Additional Offsite Well Installation and Aquifer Testing Report Lockheed Martin Corporation, Beaumont Site 2 Beaumont, California

Subject: Subject: Submittal of the *Additional Offsite Well Installation and Aquifer Testing Report, Lockheed Martin Corporation, Beaumont Site 2, Beaumont, California*

**RESPONSES TO COMMENTS ON THE ADDITIONAL OFFSITE INVESTIGATION AND AQUIFER TESTING REPORT
LOCKHEED MARTIN CORPORATION, BEAUMONT SITE 2
BEAUMONT, CALIFORNIA
TETRA TECH, INC
AUGUST 2010**

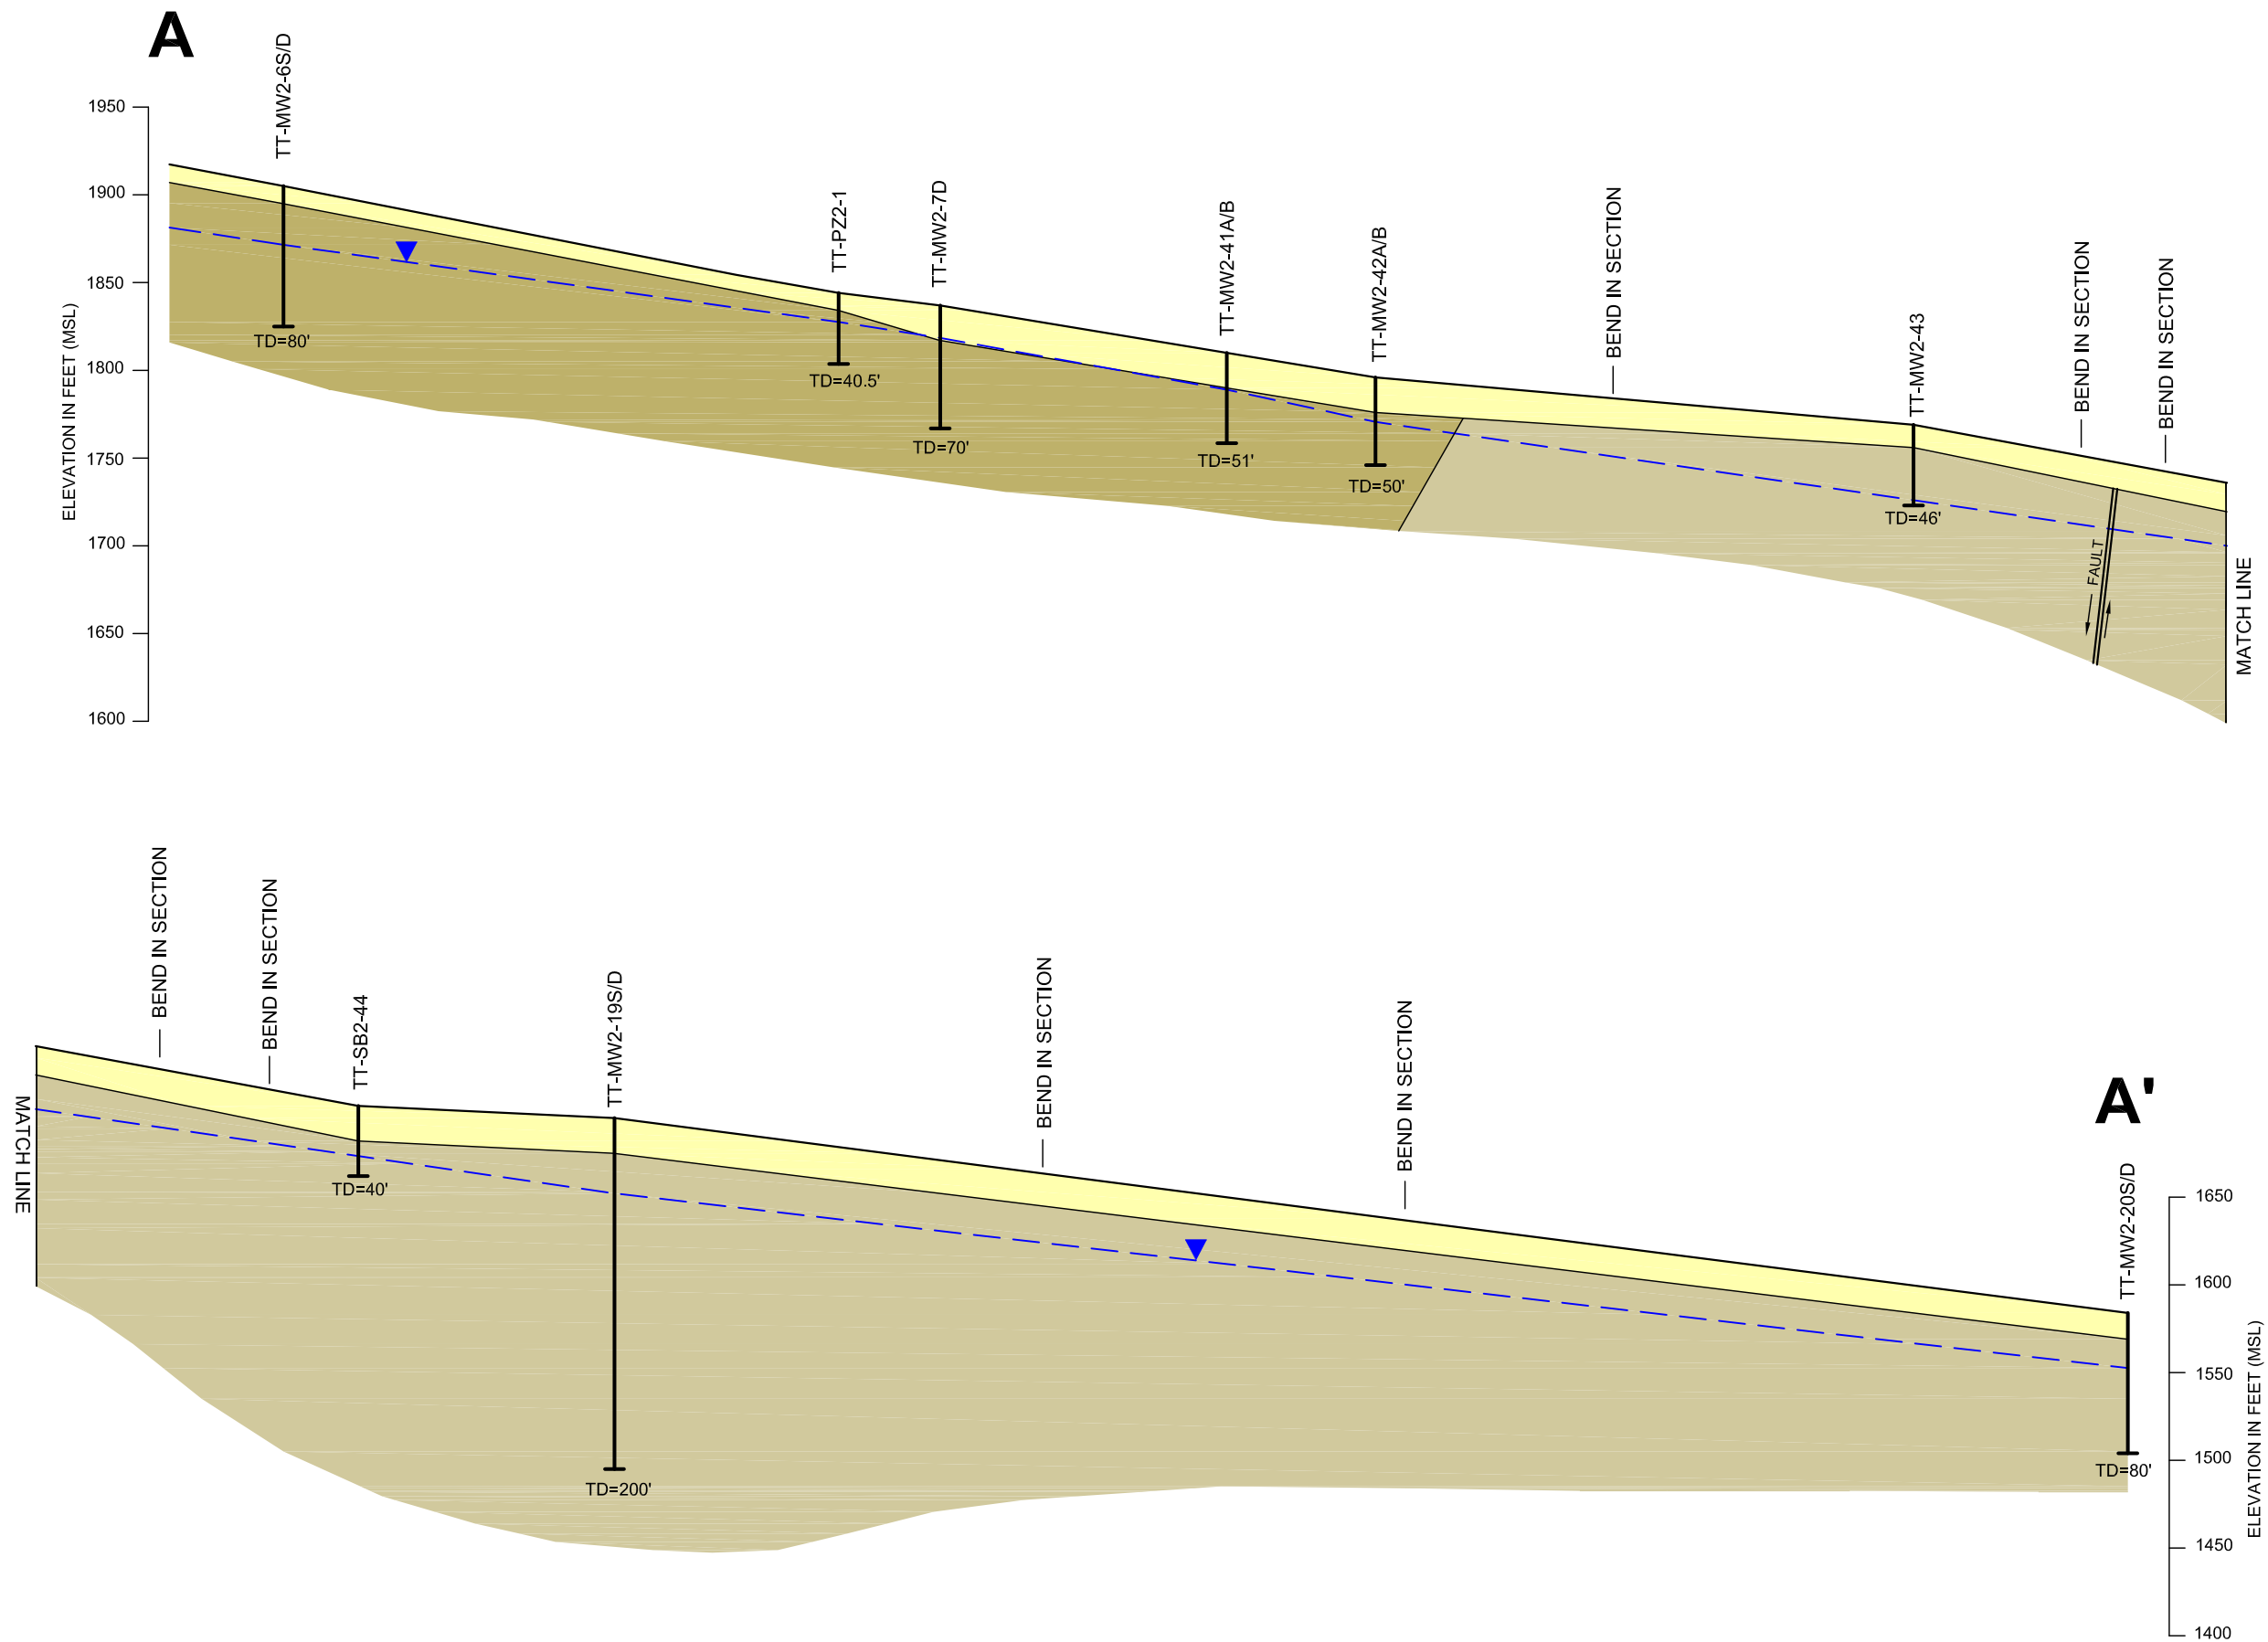
Comments from Dina Kourda, GSU		
Comment	Response	Proposed Action
<p>Specific Comment 1.</p> <p>Figure 3-1: A distinct differentiation should be made between the contact lines and “fault, accurately located showing dip.”</p>	<p>The symbol for a geologic contact in the legend of Figure 3-1, was labeled “Fault, accurately located showing dip” instead of “Contact.” This error will be corrected.</p>	<p>The legend of Figure 3-1 will be revised to distinguish between contacts and faults.</p>
<p>Specific Comment 2.</p> <p>Figure 3-5: Because of Site 2’s unique configuration, it should be explained how horizontal flow directions are calculated. It appears that the groundwater flow direction shifts slightly three times between TT-MW2-16 and TT-MW2-6S. Also, it should be specified if the groundwater gradient(s) is/are calculated site-wide or by area.</p>	<p>As alluded to in this comment, most of the monitoring wells at Site 2 lie essentially along a line due to the steep topography of the site, which limits drilling to the relatively flat canyon bottoms. As a result, groundwater flow direction cannot be determined by triangulation. The conceptual hydrogeologic model for the site suggests that shallow groundwater flow is focused within deeply weathered San Timoteo formation underlying the major canyons. This conceptual model is consistent with data showing very low to non-detectable perchlorate concentrations in monitoring wells TT-MW2-27 and TT-MW2-34A/B/C, which were installed in small side canyons off Laborde Canyon immediately south (generally downgradient) of areas with very high perchlorate concentration in groundwater (Tetra Tech, 2010b). Assuming that the canyon walls approximate a no-flow boundary, the equipotential lines are drawn perpendicular to the sides of the canyons.</p> <p>Groundwater gradients are calculated using a segmented path approximating a flowline through the canyon. Appendix E of the groundwater monitoring reports (e.g., Tetra Tech, 2010a) details the groundwater gradient calculation for both the entire site and individual segments</p>	<p>No changes proposed.</p>
